## PLANNING BOARD MEETING AGENDA

March 27, 2024 at 7:30 PM

Re: Wickes Arborists – 11 McNamara Road  
Response to Site Plan and Special Permit Review comments

The following are in response to comments prepared by Brooker Engineering, PLLC dated May 23, 2023.

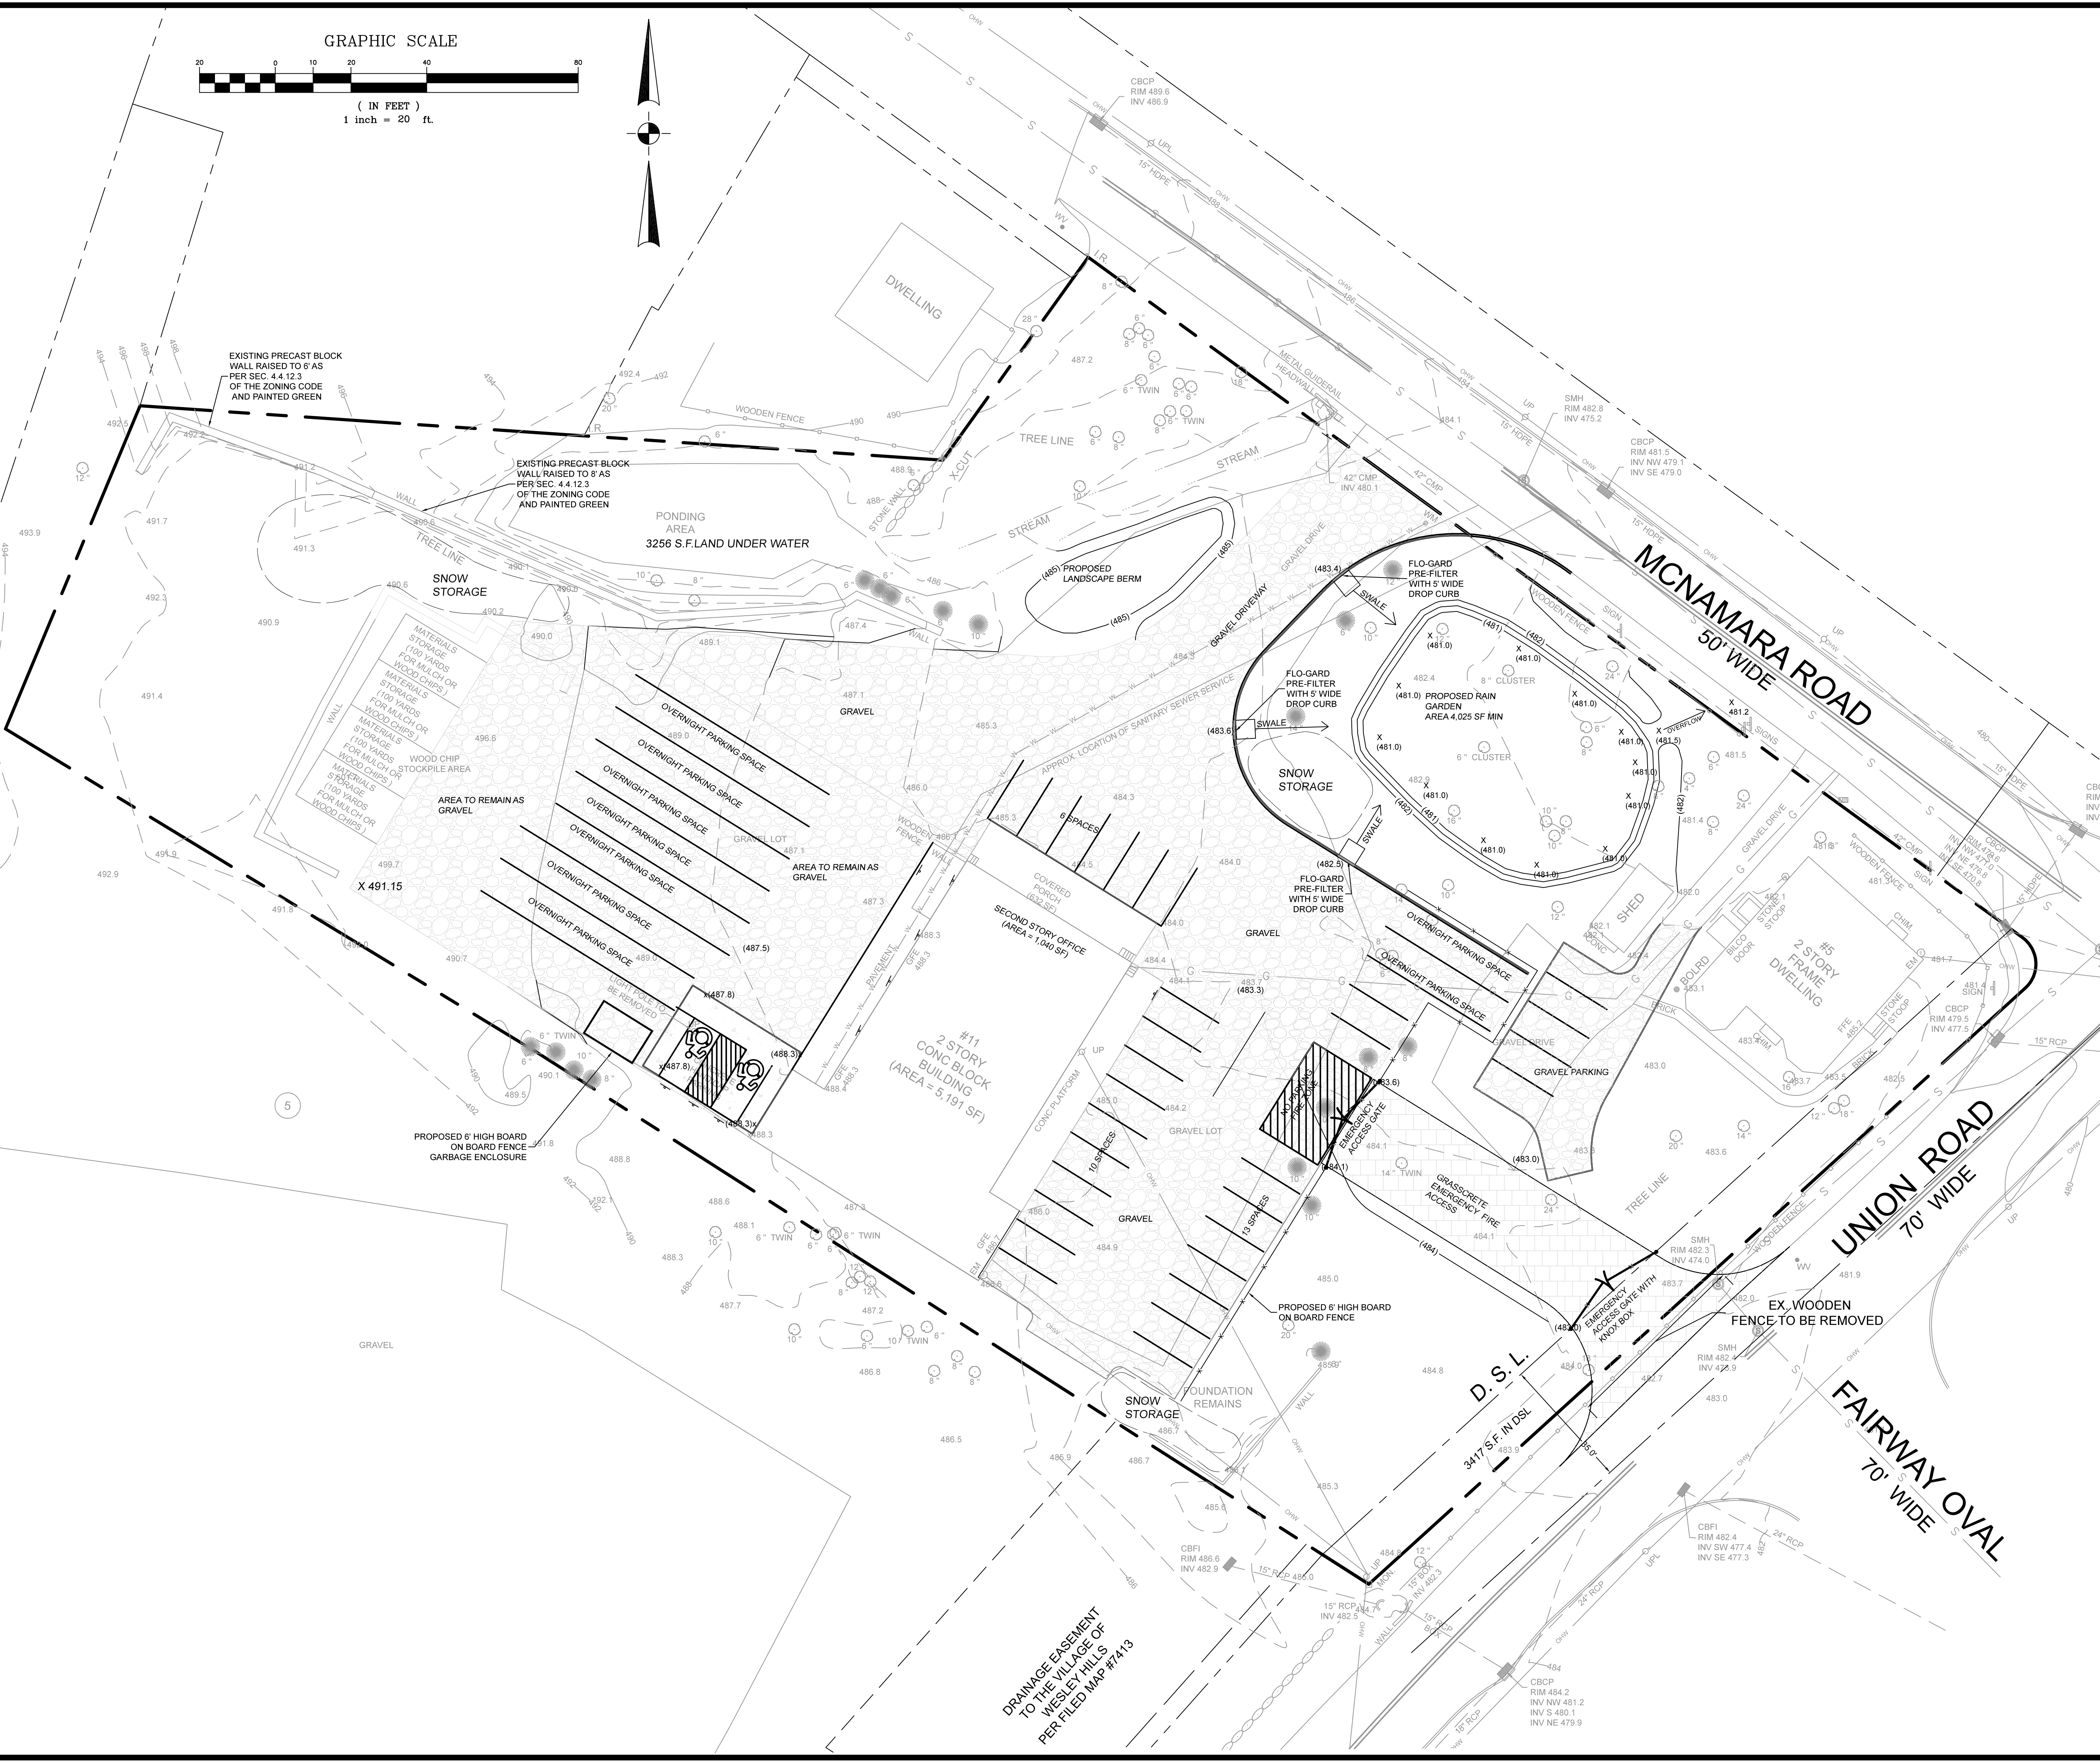
- 10. Grading detail is limited. Additional spot grades shall be provided to demonstrate:**

- 11. Additional drop curbs appear necessary to accommodate proposed configuration of catch basins/flo-gard prefilters. Outlet of catch basin to be clarified. Detail suggests a piped overflow is needed. Grading/inverts to be confirmed.**

- 13. The discharge point for the underdrain system and domed overflow riser are absent from the plan. Overflow invert, underdrain invert, and discharge location & invert shall be provided.**

Response: Additional spot grades have been provided to clarify the proposed grading in the named areas.

Response: An additional Drop curbs and an additional flo-gard pre-filter have been proposed. The overflow has been designed to flow overland in a grass swale to McNamara Road drainage system. An underdrain is not required in the rain garden if the soil infiltration rate is not sufficient. If soil testing determines an underrating is required, we will design it before construction.

Response: Overflow has been designed to flow overland in a grass swale to McNamara Road drainage system.

**MATERIAL STORAGE DETAIL**  
SCALE: N. T. S.

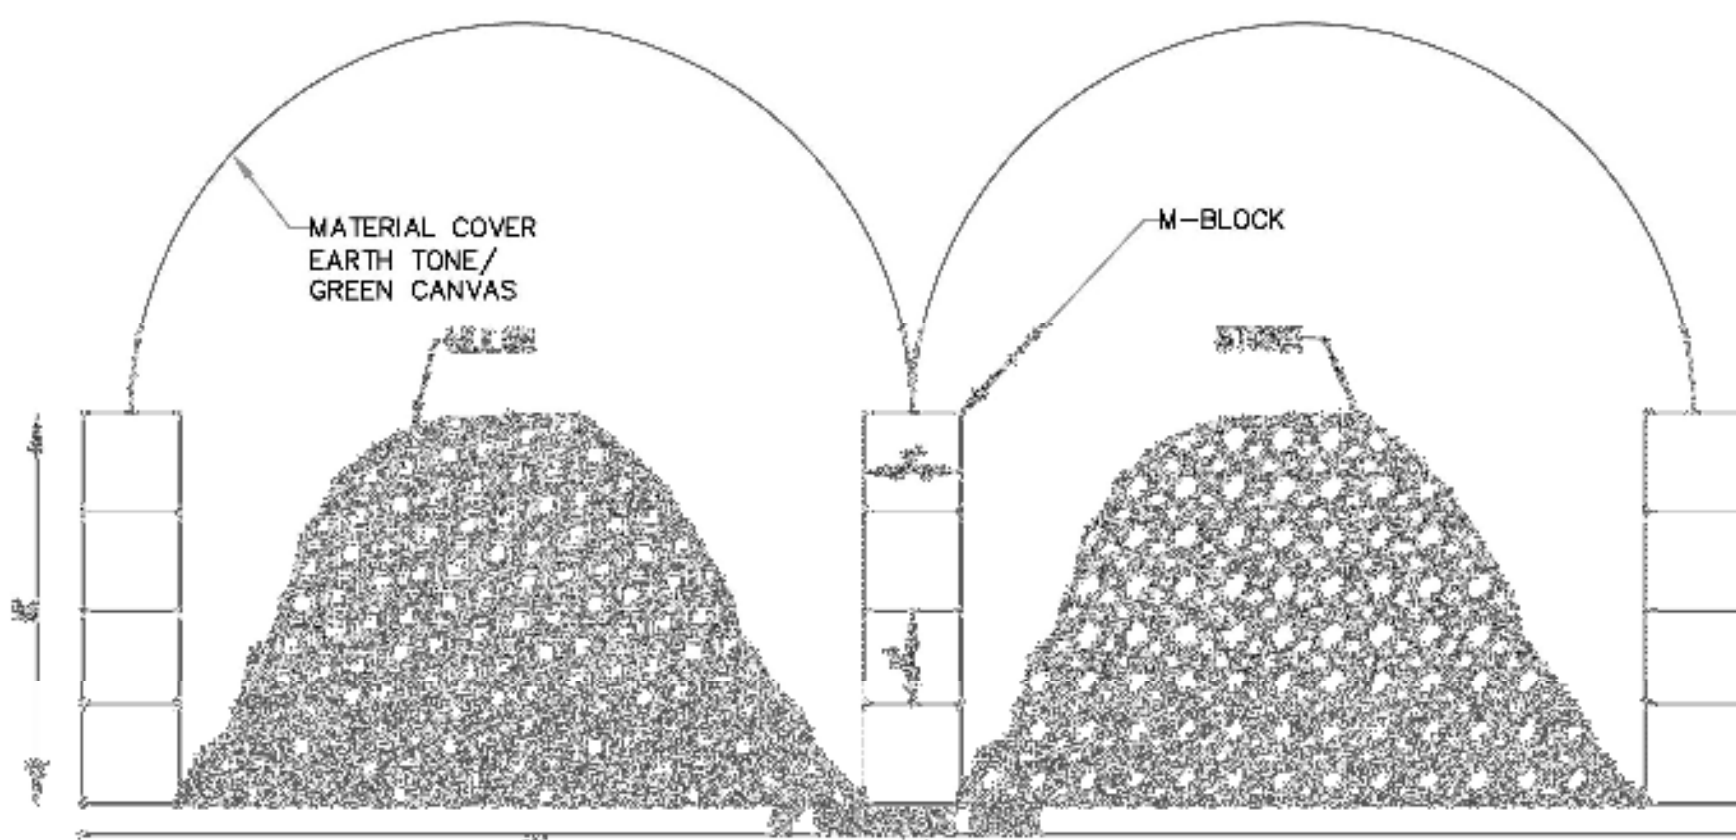
- 3. Existing material storage containment areas appear not to be in conformance with the Village code. Four 100 cubic yard containers are depicted on the plans and described in the narrative. Code allows a maximum of 25 CY for stone/gravel per container and 50 CY per container for other materials.**

Response: The Stipulation of Settlement provides the storage of 400 cubic yards of mulch and/or woodchips in storage structures with a 100 cubic yard capacity. No storage of stone and/or gravel is proposed.

**RAIN GARDEN DETAIL**  
SCALE: N. T. S.

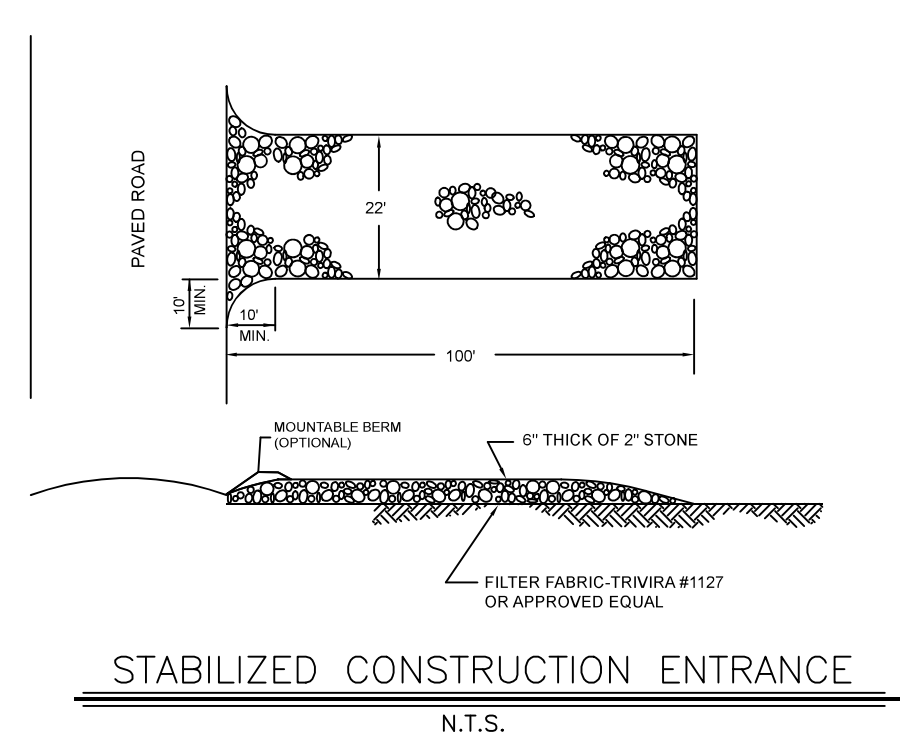
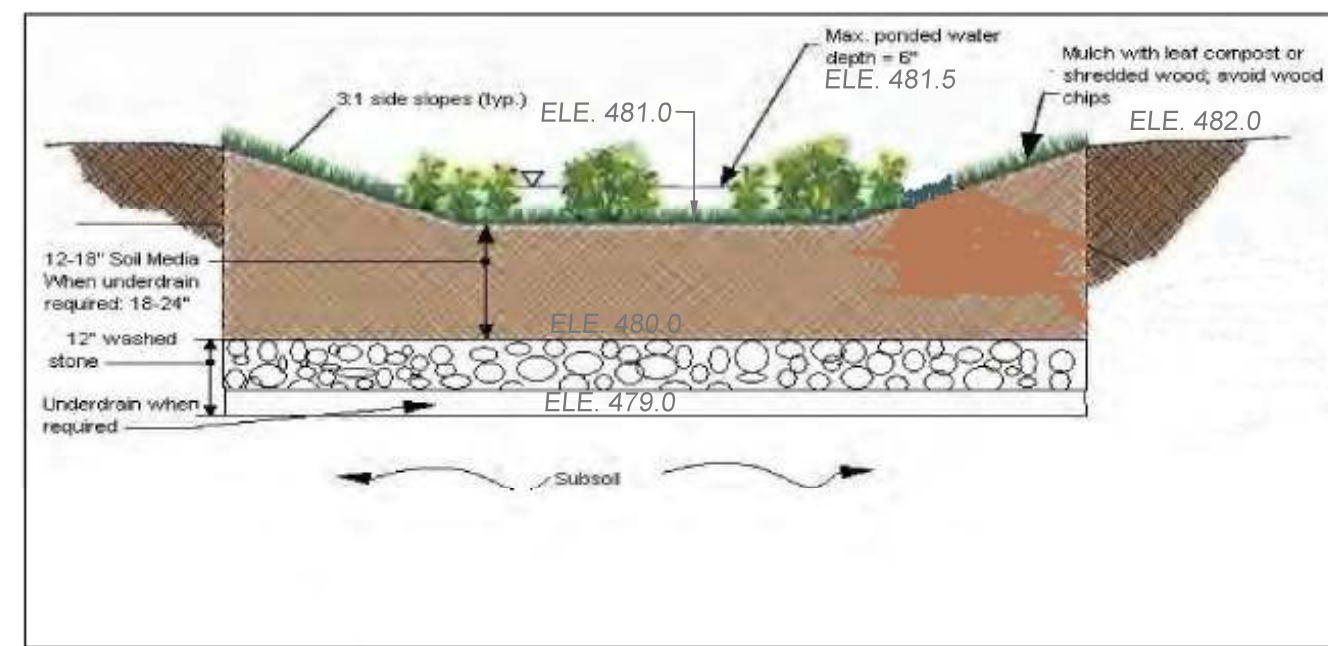
- 17. Range of rain garden soil media/stone depths to be removed and replaced with actual design depths. Elevations to be indicated on detail including domed riser, top of bank, mulch, soil media, stone, and underdrain inverts.**

Response: Additional Details are provided.

**GRASSCRETE PERVIOUS PAVEMENT DETAIL**  
SCALE: N. T. S.

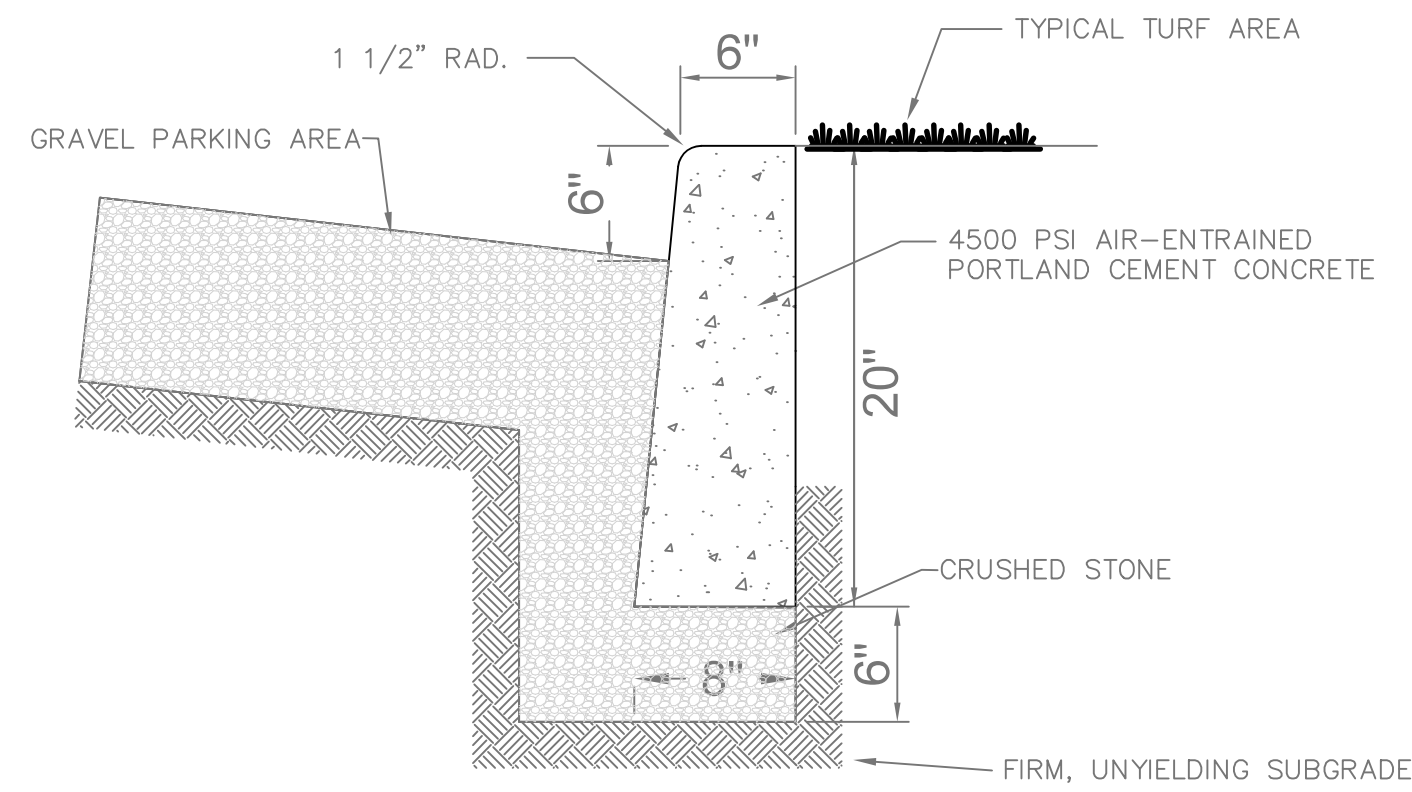
- 16. Grass-crete detail/cross section to be provided.**

Response: Additional Details have been provided.

**CONCRETE CURB DETAIL**  
NOT TO SCALE

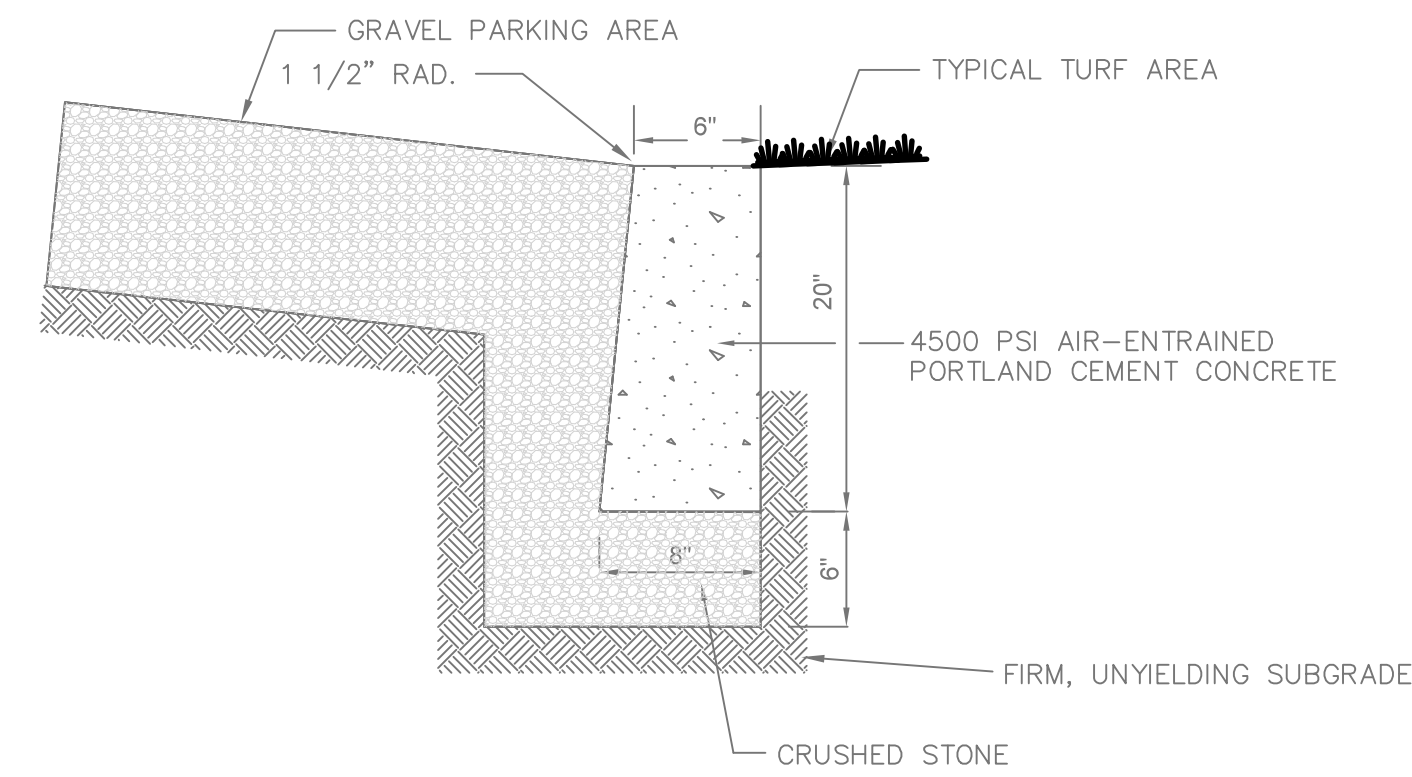
- 6. Proposed concrete curb limits to be confirmed. Previous plan set included only a limited area of concrete curb along the border of the rain garden to convey and pretreat stormwater runoff.**

Response: The Concrete curb is to be installed along the border of the rain garden to channel the flow into the rain garden through the pretreatment structures. The remaining concrete curbing has been removed.
